NORTHEAST NUCLEAR ENERGY COMPANY'S  
RESPONSE TO  
JACK R. BENJAMIN & ASSOCIATES'  
REVIEW OF THE REVISED  
MILLSTONE UNIT NO. 3 PROBABILISTIC  
SAFETY STUDY SEISMIC FRAGILITY  
May 4, 1984

DECEMBER, 1984

MILLSTONE NUCLEAR ENERGY COMPANY'S  
RESPONSE TO REQUEST  
FOR ADDITIONAL INFORMATION  
QUESTION 720.92

REQUEST FOR ADDITIONAL INFORMATION  
MILLSTONE NUCLEAR POWER STATION, UNIT 3

FIGURE 720.92-1. SCALE FACTOR,  $F_H$  VERSUS DURATION

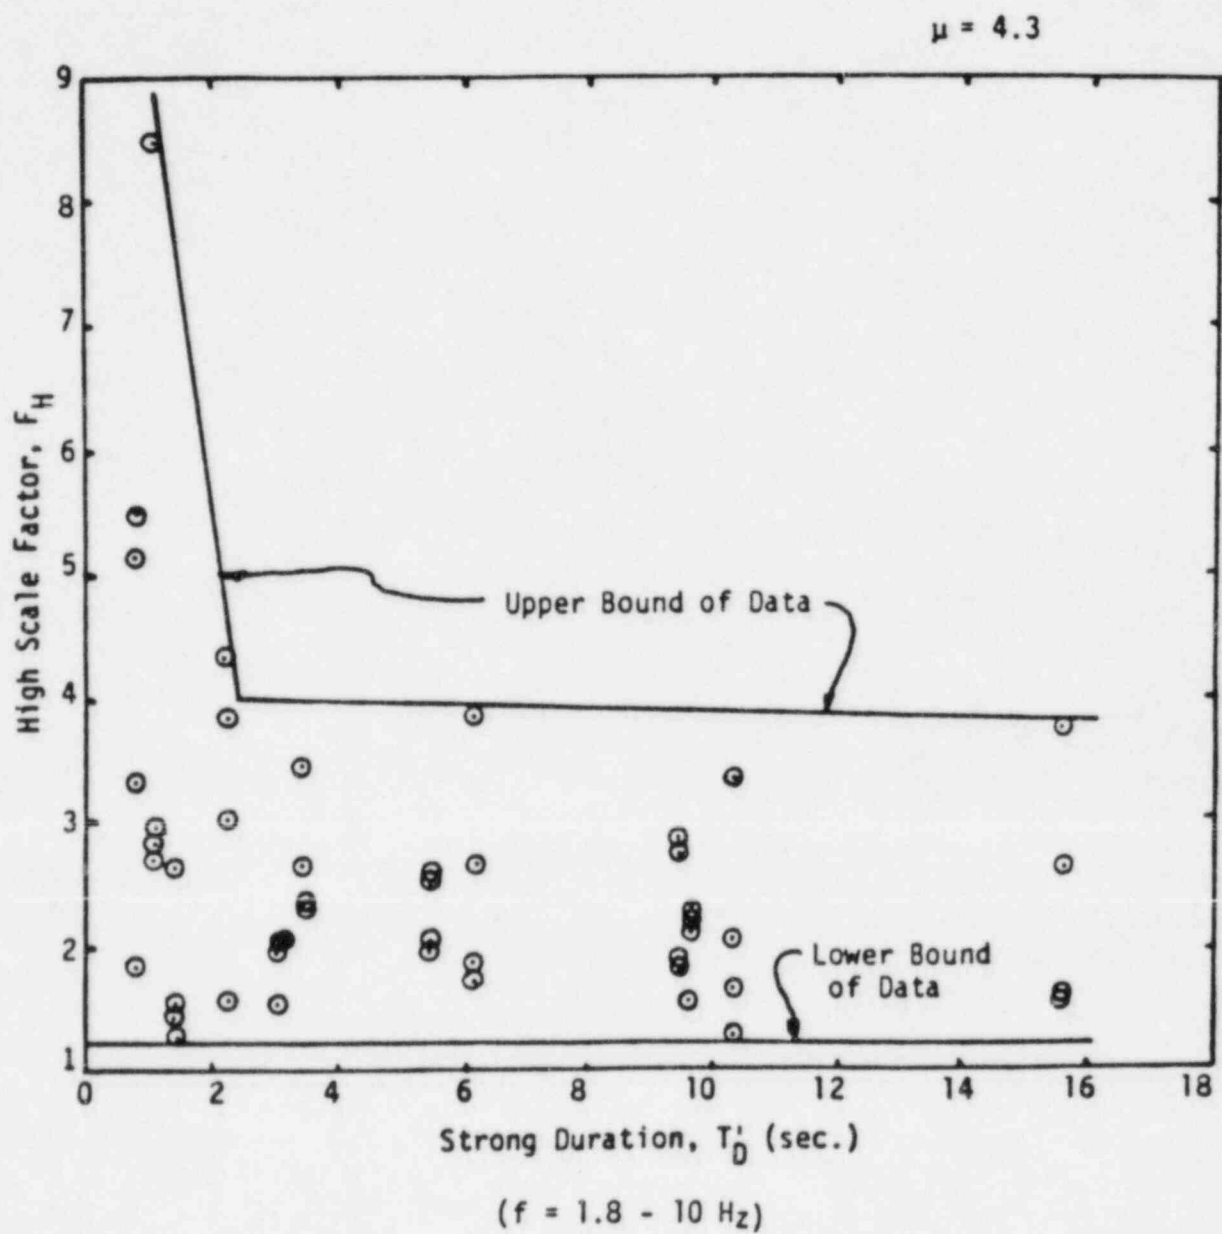
The staff also needs additional information on your statement that  $C_D$ , the correction factor on ductility, is considered to be frequency independent.

- (3) Give evidence to support your statement that  $C_D$  is considered to be frequency independent. Provide the specific  $C_D$  factors associated with the 8.54 HZ model structure frequency for Tables 4-4 and 4-5 included in the Structural Mechanics Associates seismic fragility analysis.
- (4) If the values of  $C_D$  from question (3) are lower than the  $C_D$  you have used ( $C_D = 1.3$ ), provide justification for your assumptions.

The factor of safety resulting from ductility effects,  $F_\mu$ , is dependent on both duration and spectral shape. Figure 720.92-1 is reproduced from Reference 3 and clearly shows the effect of strong motion duration for a ductility ratio of approximately 4.3. However,  $F_\mu$  is most strongly influenced by the spectral shape and the frequency of the structure. Table 720.92-1 is also reproduced from Reference 3 and shows the  $F_\mu$  factors for the various earthquake records and structure frequencies for the 4.3 ductility ratio.
